Hydraulics and Hydrology Memorandum

| Project: | Monument Academy Recirculation Project |
| Subject: | Hydrologic Analysis and Hydraulic Assessment |

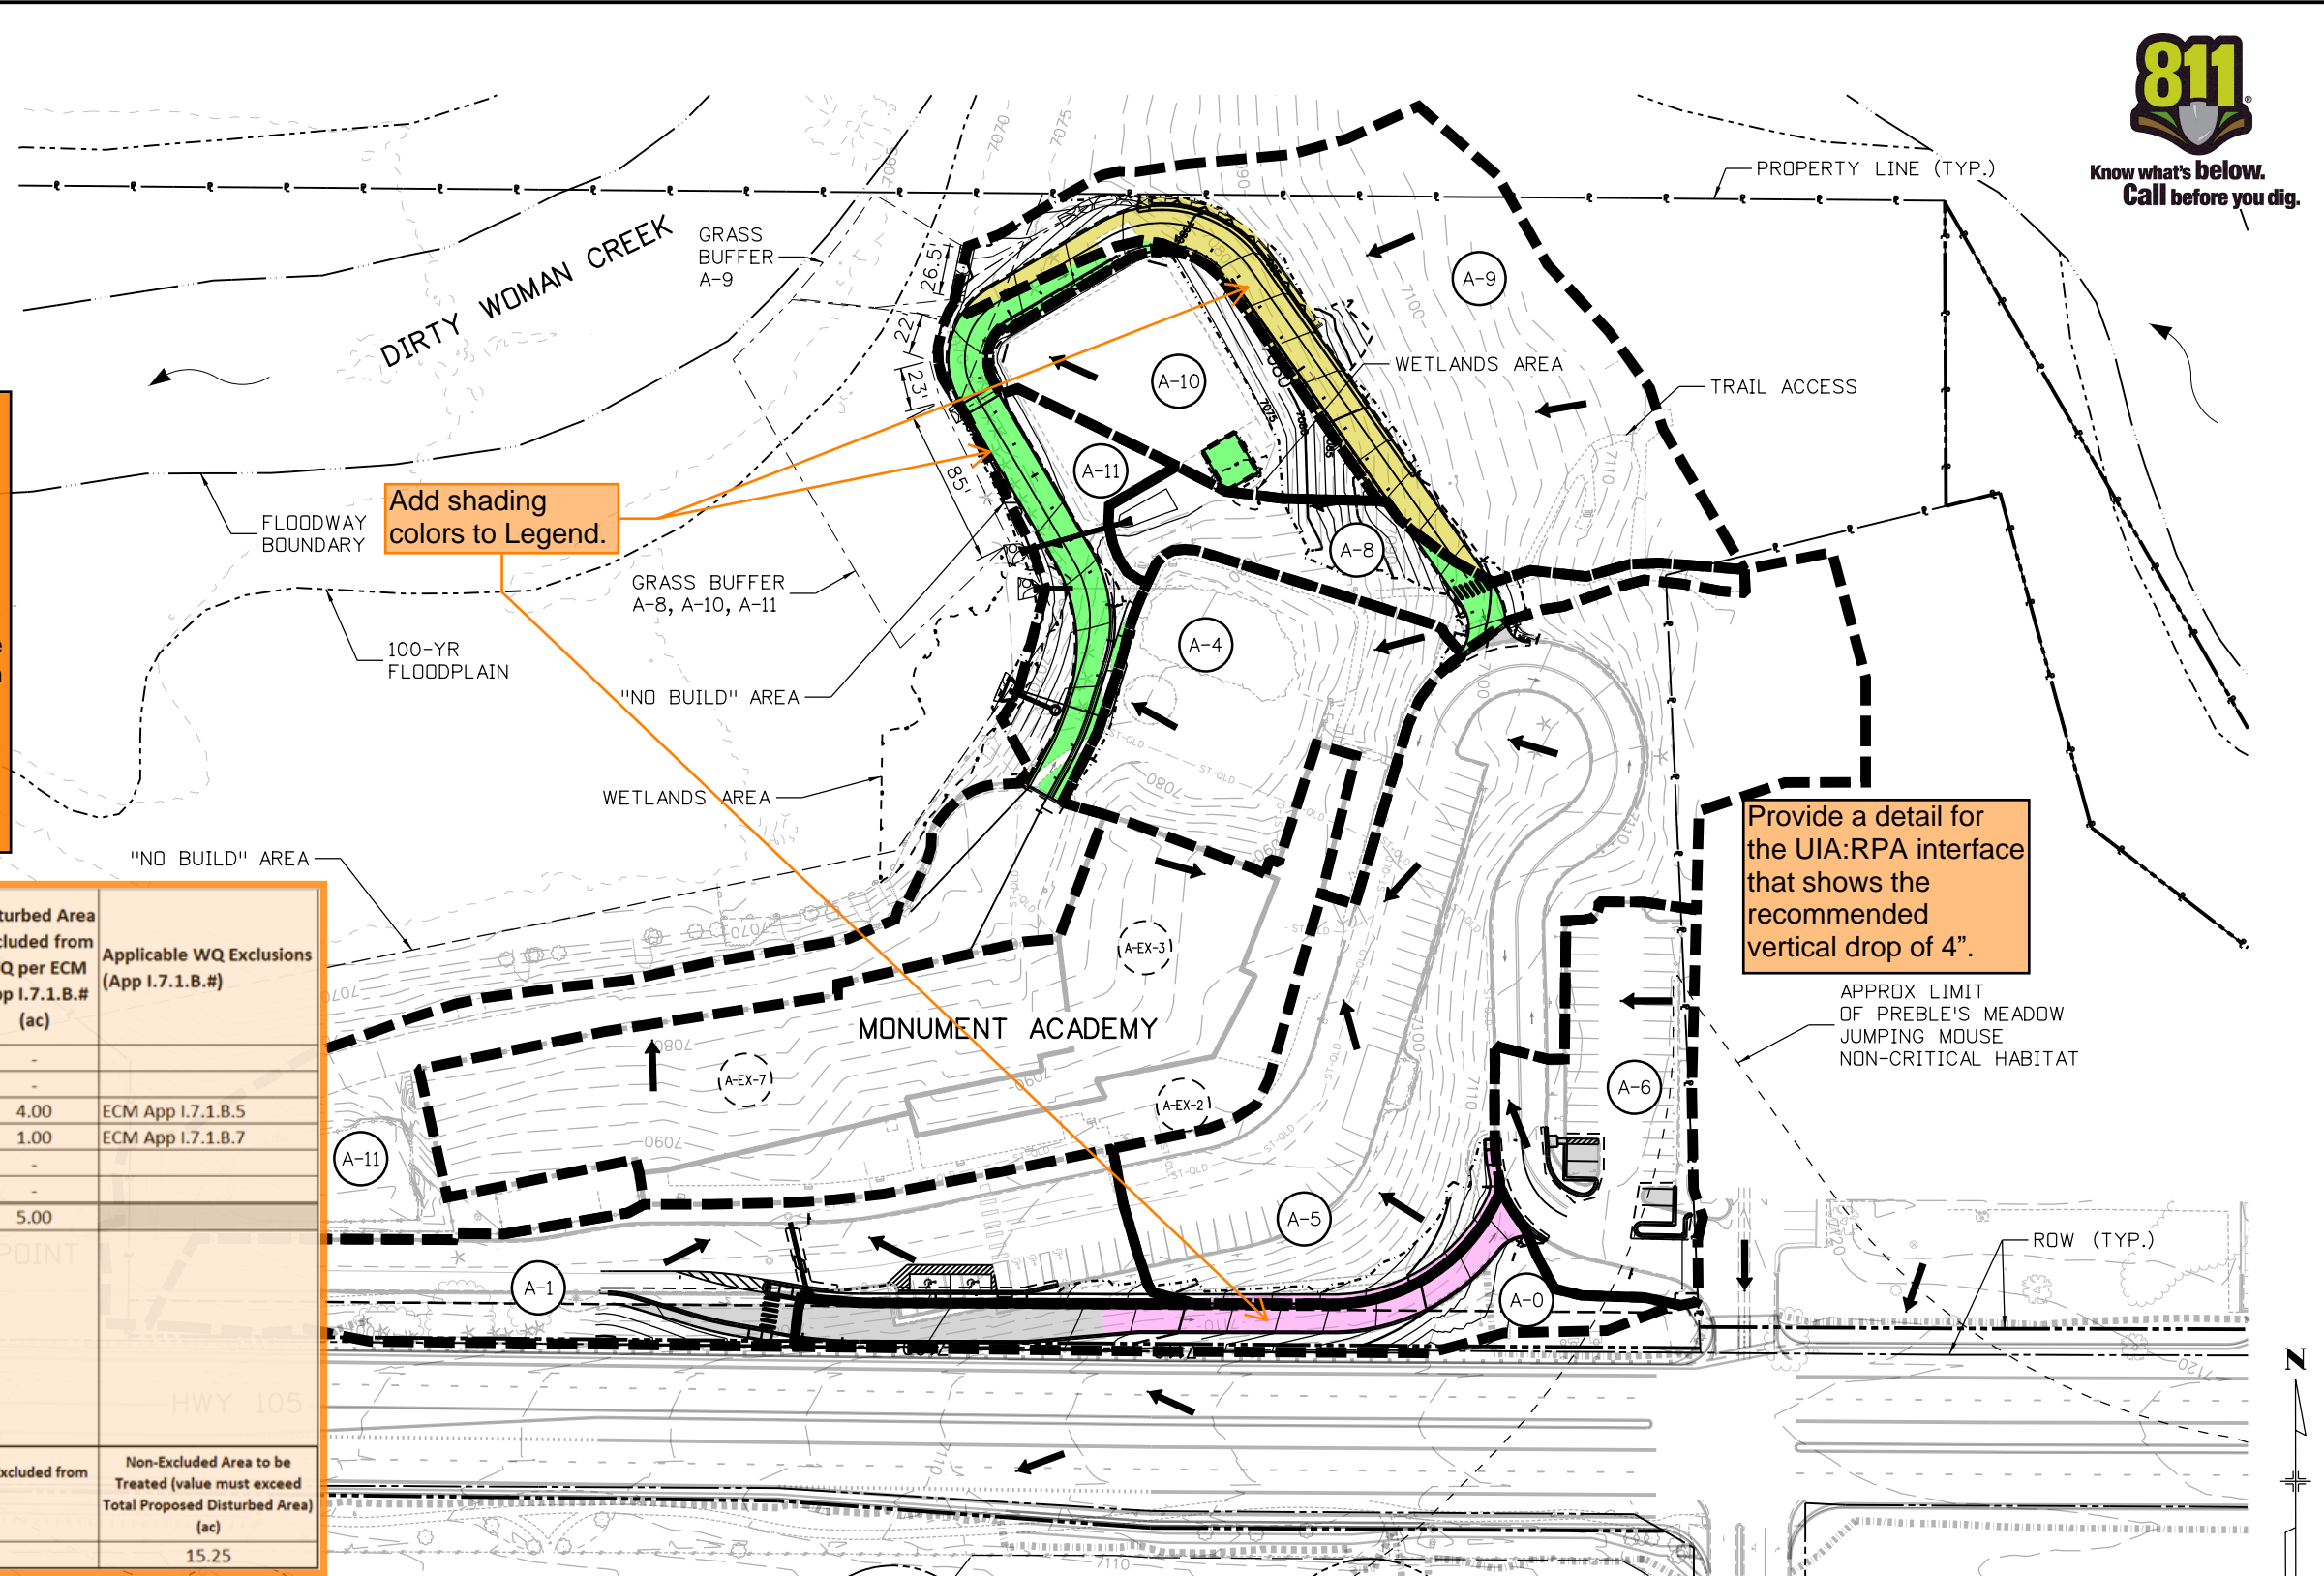
Provide a detail for the UIA:RPA interface that shows the recommended vertical drop of 4".
